## Ag 26-32 Pad Additional Siting Rationale information

As part of our review of the Siting Rationale of the production facilities proposed for this location, two questions came up.

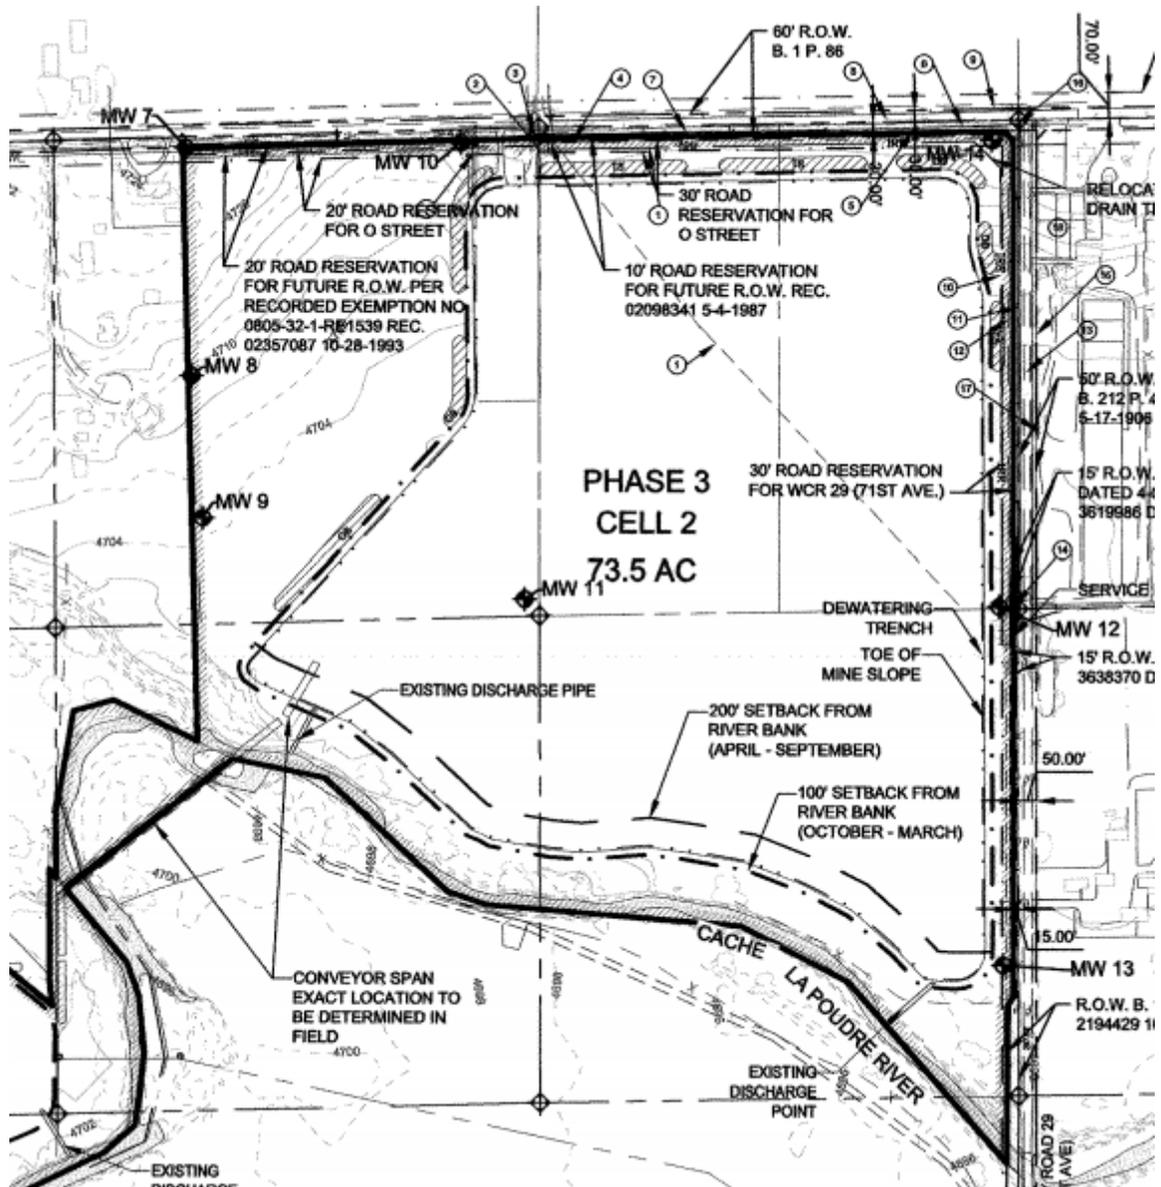
When you state: "[The future use of the property to the east and southeast is planned and approved for gravel mining.](#)" I understand what you mean when you refer to the property to the east, but when you say southeast, where exactly do you mean by that? The southeast portion of the parcel this location is being proposed on, or on another separate parcel to the southeast? Can you show that on an aerial to more easily identify it? Thanks.

Yes, southeast of the proposed wells is planned for mining. Attached the USR for you too.
